**West Vaughan Sewage System
Environmental Study Report
Addendum**

The Regional Municipality of York

Contract P-13-43

January 2016

Figure 8: Tunnel Alignment from Highway 7 to the Humber PS

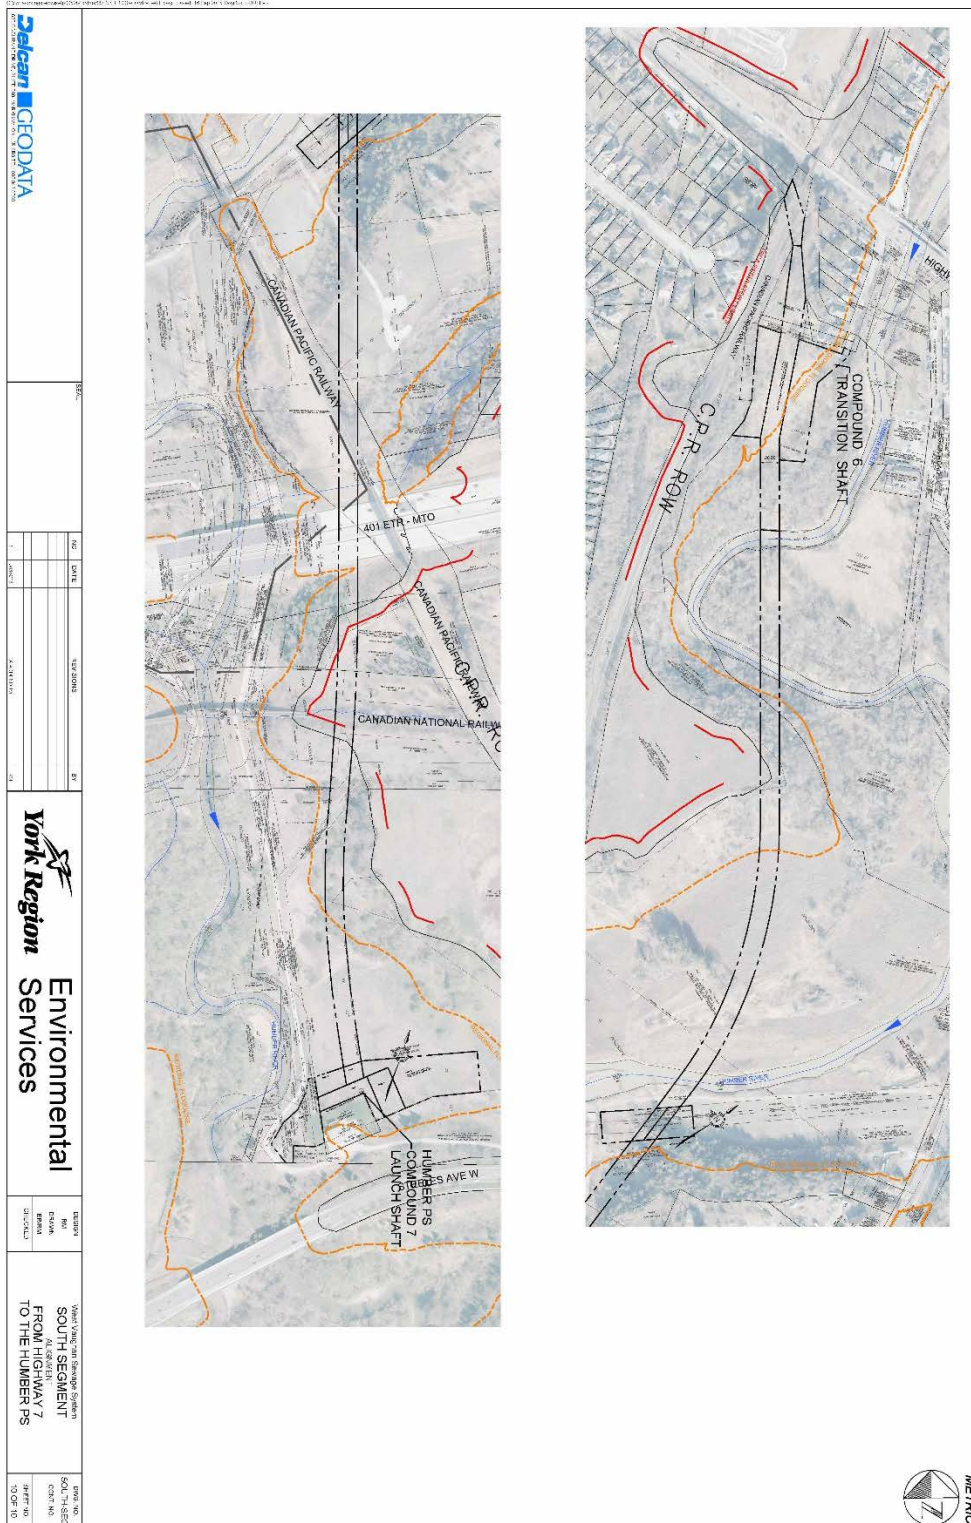
Modifications to the Southern Segment tunnel alignment were made in order to expand the Central Segment tunnel in bedrock, while mitigating the TBM tunnel transition from bedrock to soil below sensitive surface infrastructure (road/railway bridges and private land). The Southern Segment’s configuration recommended in the ESR originally identified five maintenance shafts and a launch shaft at the Humber Pumping Station (PS). Additional review has resulted in the elimination of three maintenance shafts, resulting in two shaft locations (Compound 6 and Compound 7MS) and fewer potential disturbances. The new configuration also moves Compound 6 away from the active railway and highway bridge structures.

Table 4 documents the proposed changes to the property requirements originally identified in the ESR. **Figures 2–to-7** illustrate the site plans for those compounds located within the Preliminary Design Proposed Alignment. **Figure 8** depicts the alignment as it runs from Highway 7 to the Humber PS.
